DUKE ENERGY'S RESOURCE PLANS FOR THE CAROLINAS: AN EVALUATION AND ALTERNATIVE APPROACH

FEBRUARY 17, 2017

Natural Resources Defense Council, Sierra Club and Southern
Alliance for Clean Energy

Daymark Energy Advisors

Figure 1: Duke Energy Carolinas Residential DSM Supply Curve⁶ with Additional EE Potential

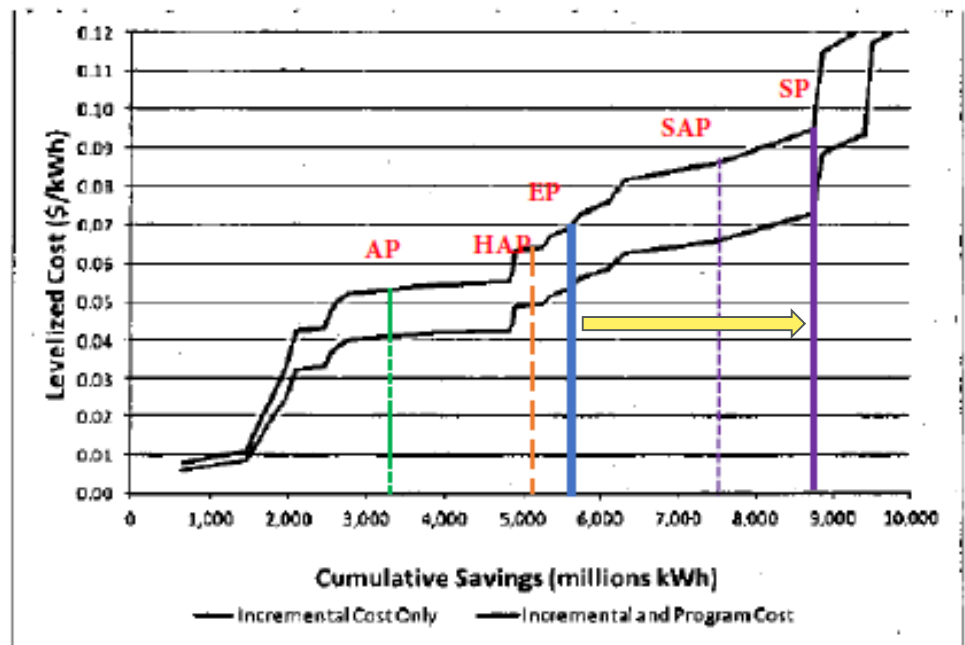
Figure 1 contains the residential energy efficiency supply curve from DEC's EE Potential study along with potential additional EE savings. DEC should consider additional EE savings from residential programs to the strategic potential⁴ (SP) line in Figure 1. This figure illustrates where Economic Potential (EP) is established by comparisons to avoided costs. Duke limits its analysis to two bundles on energy efficiency, 60% of economic potential as Achievable Potential (AP) and 90% of economic potential as the High Achievable Potential (HAR). Daymark views that economic analysis will occur during the portfolio evaluations and thus established a Strategic Additional Potential (SAP) as 60% of the Strategic Potential (SP). The reason for considering new potential at the point specified by vertical SP line in Figure 1 is due to inelastic portion of the supply curve. The levelized cost of electricity for obtaining marginal EE savings beyond SP line increases substantially. Moreover, the resulting levelized cost at the SP line is little above \$0.09/kWh which is still lower than the cost of additional nuclear generation shown in Figure 6, Appendix A. DEC residential EE programs have possibility of attaining additional 3100 GWh of savings by shifting from economic potential to strategic potential. Using the DEC's method of considering 60% of economic potential to estimate achievable portion, DEC has 1860 GWh⁵ of energy savings from EE programs to consider in its long-term plan. Daymark used similar method to estimate additional energy savings from DEC's non-residential EE programs. DEC can

attain additional 1300 GWh of savings by pushing the EE potential to strategic potential.

Figure 5: Comparison of PVRR across Different Cases from Daymark Modeling and IRP reported PVRR

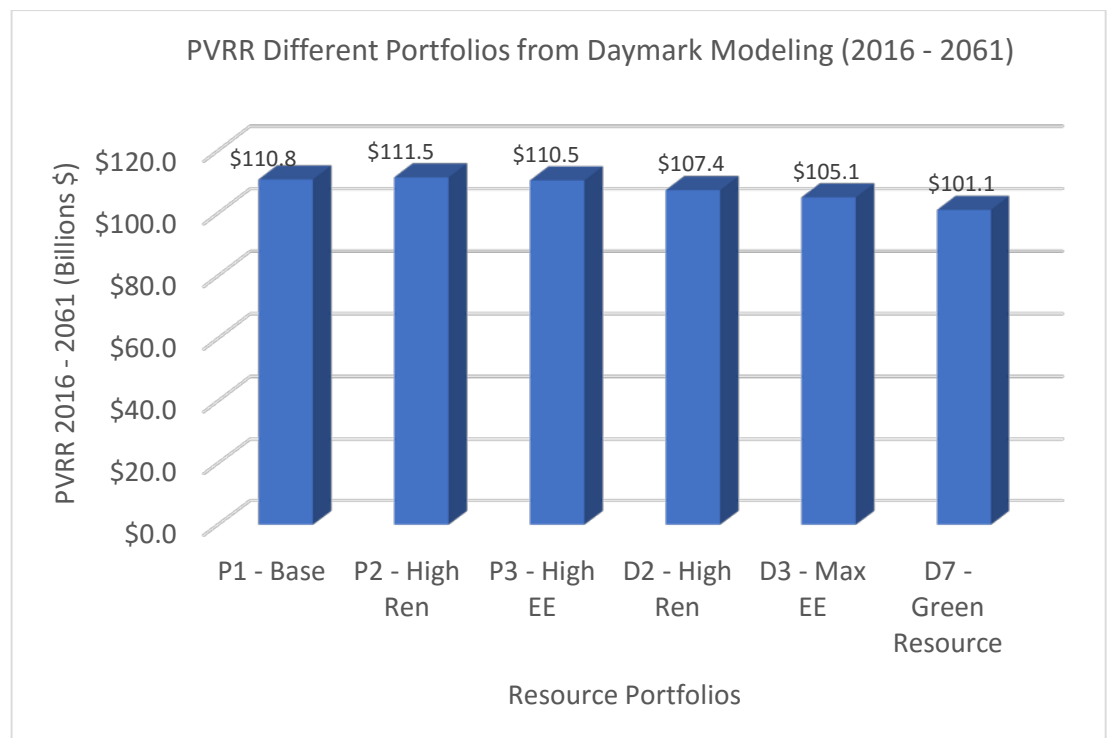
Daymark first compared the cost of its portfolios to those reported in the IRP by Duke. In Figure 5 below, orange bars show the PVRR reported in the IRP, whereas the blue bars are estimated by Daymark’s modeling work. The PVRR number in the figure is combined for DEC and DEP service areas. The figure also includes the PVRR of three alternative cases that Daymark developed where the LTCE did not include proposed Lee Nuclear units. The results show that alternative cases are lower cost options compared with portfolio analyzed by Duke. Daymark’s alternative Case 7 (D7 – Green Resource Options) that also contains additional EE, solar, and wind generation is the least cost option among the portfolio analyzed.

Figure 6: Comparison of Levelized costs (cents/kWh) by energy sources

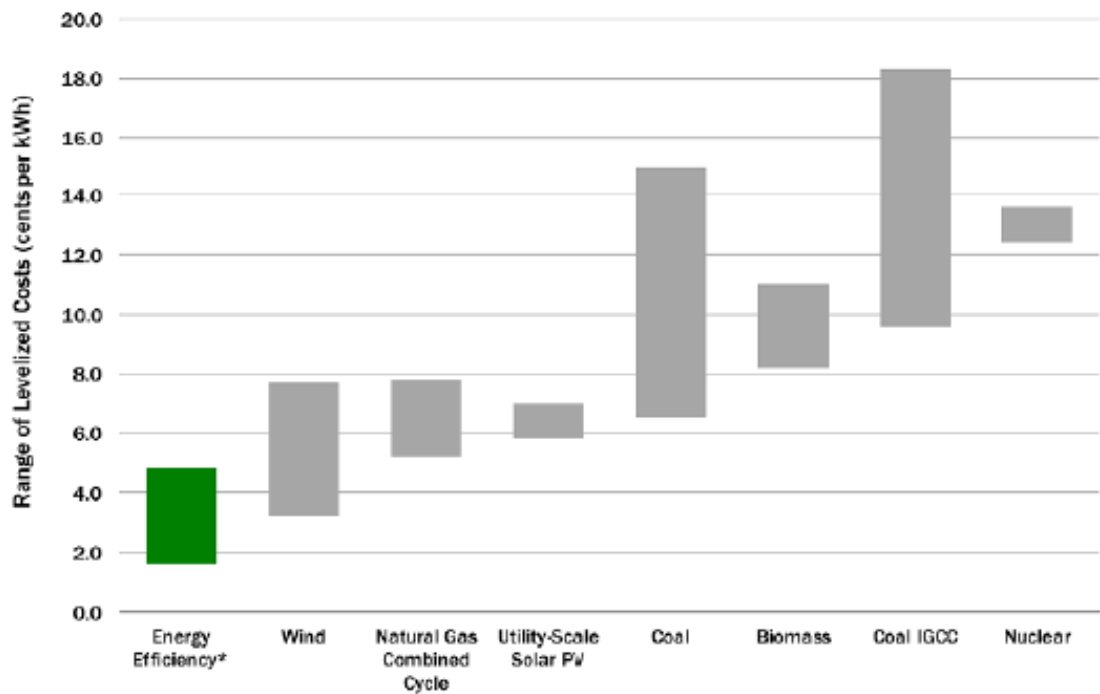
The development of the IRP EE and DSM options begins with a resource potential study. The energy efficiency resource potential considers the economic forecasts driving energy consumption, the existing end-uses of electric power for each customer class, the existence of replacement more efficient equipment, the potential for building shell improvements and the continued technology evolution that creates opportunities to have new equipment be installed and utilized that is most efficient. A thorough potential study identifies a 'supply' curve of energy efficiency resources for each customer class showing an increasing cost as more and more energy efficiency options are considered. The top end of these supply curves would be termed the technical potential. Based on existing program experiences, and the most recent market potential study, the potential study identifies 'achievable' potential levels. In most utility IRP screening analysis, the supply curve is utilized to establish a level of 'economic' potential. This is where Daymark believes that the energy efficiency resource is prematurely limited. The economic potential is established utilizing supply costs, i.e. avoided costs, to determine the amount of energy efficiency that is deemed economic. As discussed earlier in this document generation or supply resources do not undergo such testing. Figure 6 below illustrates how the costs of the various resource options compare on a generic basis. This comparison shows energy efficiency to be

significantly lower than some generation options. Thus, by limiting the size of the energy efficiency resource at this stage, the opportunity to evaluate strategies or portfolios to determine the potential role for all energy efficiency rather than generation resource options are pre-empted. At this point in the evaluation process, screening, we do not know if portfolios could be enhanced by replacing additional higher cost supply options illustrated on this chart with energy efficiency.
